Hi-Fi Products
Service Bulletin

Model: CDP-C315

No. 297

Subject: Chassis Replacement

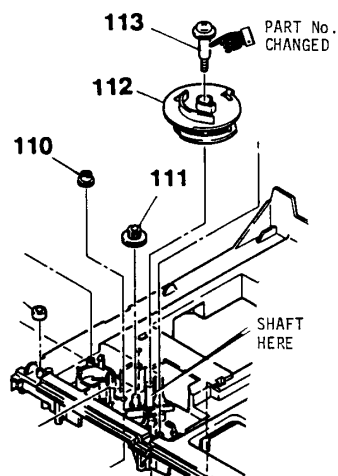
Chassis Replacement Part (Ref. 120, P/N 4-943-997-01) is different from original. The new replacement chassis has a shaft for mounting Cam Gear Ref. 112. When replacing the chassis, it is also necessary to replace the Hold Down Screw Ref. 113.

Order the Chassis and the Cam Gear Hold Down Screw as shown in the chart below:
